US-APWR

**MHI's Supplemental Responses to NRC's Questions
for NRC's Acceptance Review
of the US-APWR Design Certification Application**

February 2008
(Non-Proprietary)

Step Sequence for SGTR Operator Actions

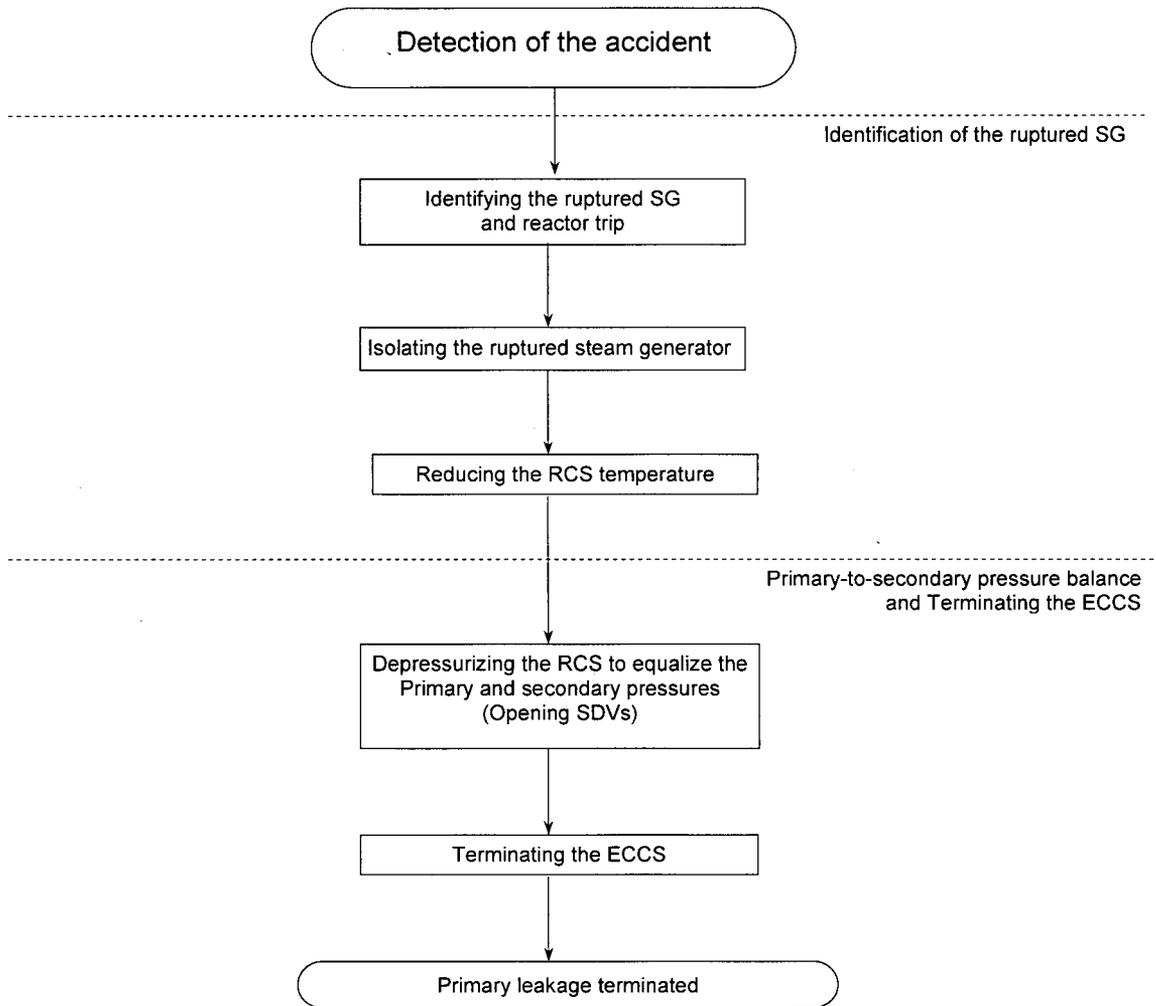
NRC requests MHI to provide Emergency Response Guidelines (ERGs) for operator actions credited in the Chapter 15 safety analyses of the US-APWR Design so that the NRC can verify that future plant Emergency Operating Procedures (EOPs) will correspond to operator actions assumed in the Chapter 15 safety analyses.

The chronology of each event requiring operator actions is similar in that after the event occurs, the operator becomes aware that the event has occurred and in most cases, performs a simple (and many times single) action that terminates the event. Because of this similarity, flow charts of the event progression from initiation and cause identification through termination are not provided for each event. The Steam Generator Tube Rupture event, however, is more complex. The flow chart presented on the following page is provided to illustrate the sequence of manual operator actions for that event. It should be noted that information related to the timing of the actions and the acceptability of the response time is described in the DCD, not in this response. The purpose of this submittal is to provide the plant conditions (as defined by combinations of parameters and values, as well as the source of the information) under which specific operator actions can or cannot be taken as they relate to the events analyzed in Chapter 15 crediting operator actions.
